Application No: 2016/0289/C

Proposal: Details of works to the Regent's Canal walls associated with the formation of Camley Bridge, etc.

Camley Bridge
Reserved Matters Submission

St. Pancras Cruising Club

Boundary Fences

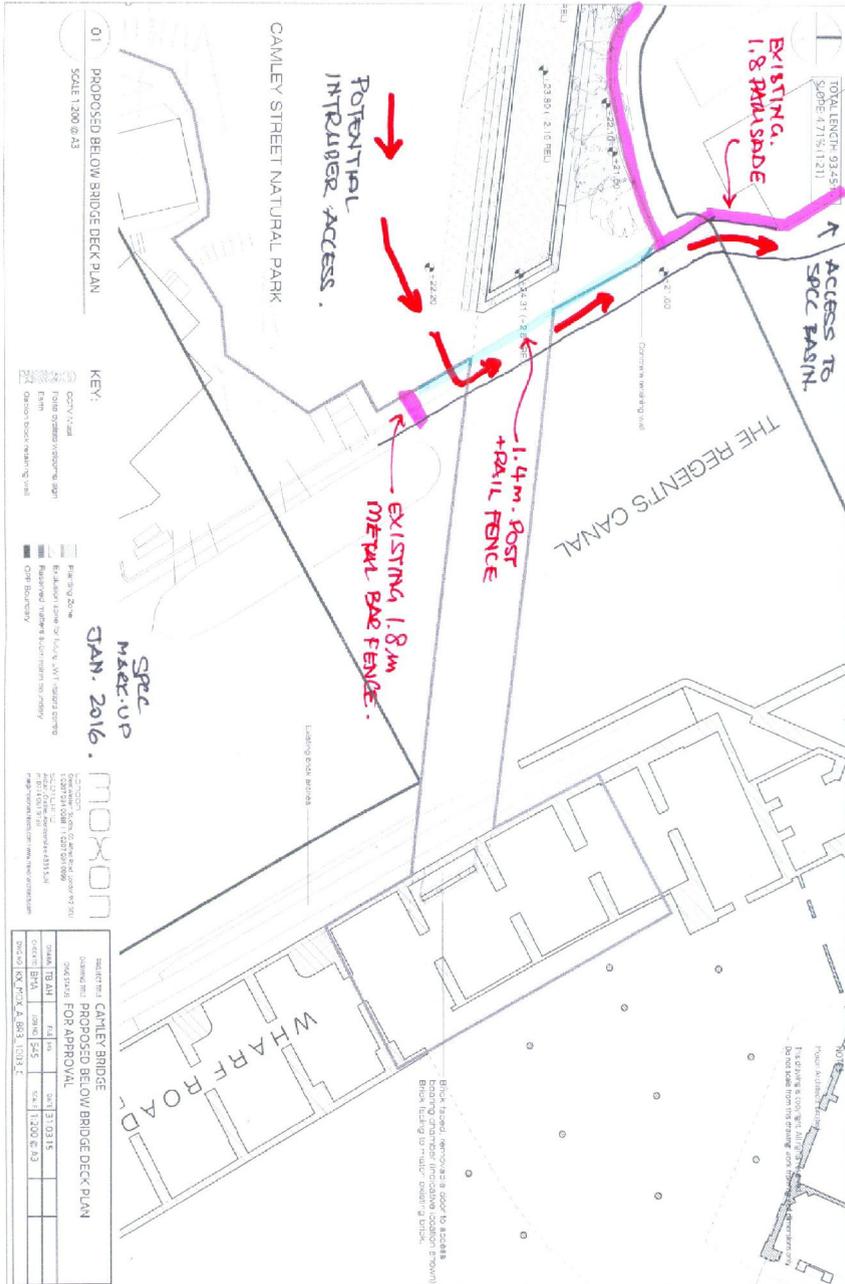
Whilst the proposed fence on the northern boundary is 2.2 m compared to the existing 1.8 m fence, it is proposed to be a chain link wire fence on timber posts against the current heavy timber post 'stockade' backed with extensive planting. Such a considerably lighter construction will require good and frequent inspection and maintenance to retain it in a secure condition

The description of the Camley Street boundary treatment as visually more permeable also reinforces that the proposals will open up to view areas that are currently only glimpsed through gaps in fences and hedging.
